Planning Commission Report

Meeting Date: August 7, 2014

Subject: **1127 Miradero Road**
Zone Text Amendment and Variance
Request for a Zone Text Amendment to Beverly Hills Municipal Code Section 10-3-2502(B)(2)(b) regarding development standards for the maximum allowed floor area on single-family properties located in the Hillside Area of the City that range from 15,001 and 25,000 square feet in area, and were constructed prior to 1997. As an alternative to the Zone Text Amendment, the applicant also submitted an application for a Variance to allow an addition to the existing single-family residence that would cause the floor area on the site to exceed the maximum floor area permitted pursuant to Beverly Hills Municipal Code Section 10-3-2502. The Variance, if approved, would be in-lieu of the Zone Text Amendment.
PROJECT APPLICANT: Tom Levyn

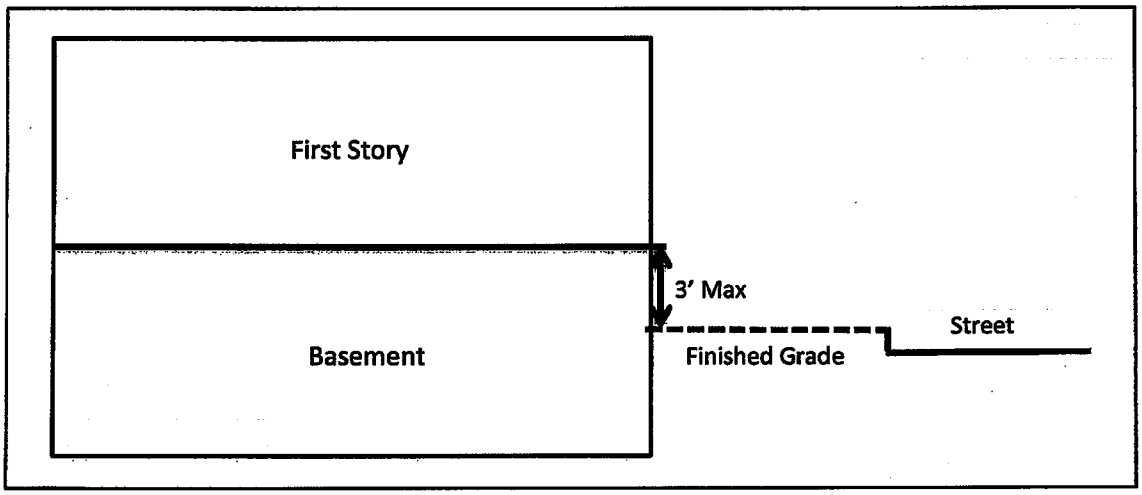
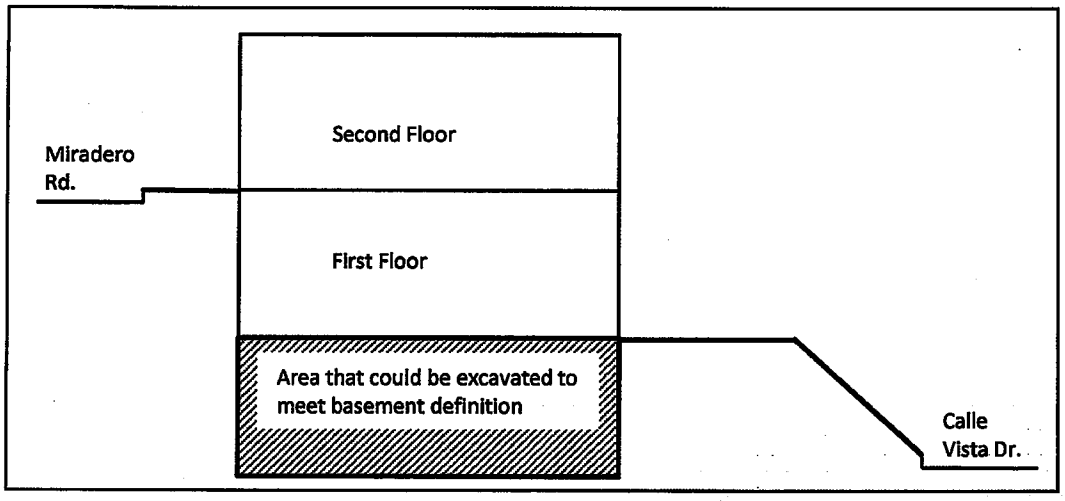
The project site is somewhat unique in that it is surrounded on three sides by Miradero Road, Schuyler Road, and Calle Vista Drive. As a result of this configuration, the project site is considered to be a 'through lot' as defined by the Municipal Code[5]. Consequently, the property lines along Miradero Road and Calle Vista Drive are front property lines, while Schuyler Road is considered to be a street side property line, and the west property line is a side property line. The property does not contain a rear lot line/yard. Pursuant to the Municipal Code, a basement shall mean "any floor level below a story which has a finished floor level that is a maximum of 3' above grade at any point along the perimeter of the building facing a front or street side setback line". The image below illustrates the definition of a basement:

Due to the configuration of the streets surrounding the project site, in order to meet the definition of a basement, the first floor could not be exposed by more than 3' on any side facing Miradero Road, Schuyler Road, or Calle Vista Drive. The topography of the project site, which slopes downhill from Miradero Road towards Schuyler Road and Calle Vista Drive, limits the ability to construct a first level that meets the definition of a basement without involving the excavation of a large amount of the hillside that exists below the existing single-family residence. The image below provides a simple section of the existing conditions on site (section from Miradero Road to Calle Vista Drive) and indicates the area of earth that would require excavation in order to construct a basement on the project site as defined by the Municipal Code.

Due to the topographic condition on the project site as well as the configuration of the configuration of the property between Miradero Road, Schuyler Road, and Calle Vista Drive, development potential on the site tends to be more limited than might otherwise be experienced on properties of a more typical lot and street configuration.
